INSPECTION REPORT
Sedimentation Structure
BM-SS
Black Mesa Mine
Navajo County, Arizona
for
PEABODY COAL COMPANY

Dames & Moore
10139-011-22

SITE PLAN
BM-SS

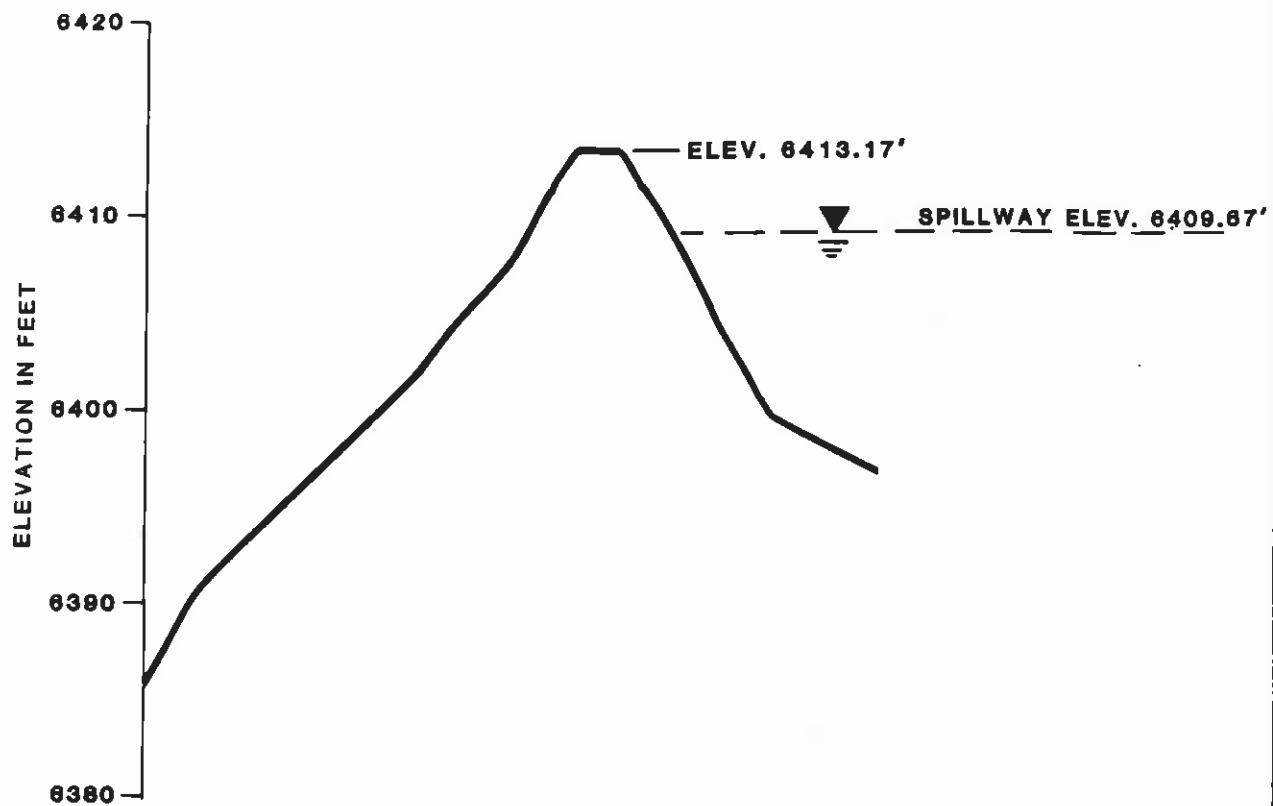
The storage capacity and spillway capacity of Structure BM-SS are adequate; however, the spillway does not have an adequate outflow channel or adequate erosion protection. A trapezoidal outflow channel should be constructed along the alignment B-B' shown in Plate 1. The channel profile is shown in Plate 4 and the required dimensions are shown in Plate 5. Both the spillway and outflow channel should be protected against erosion using geotextile and gravel as shown in Plate 5.
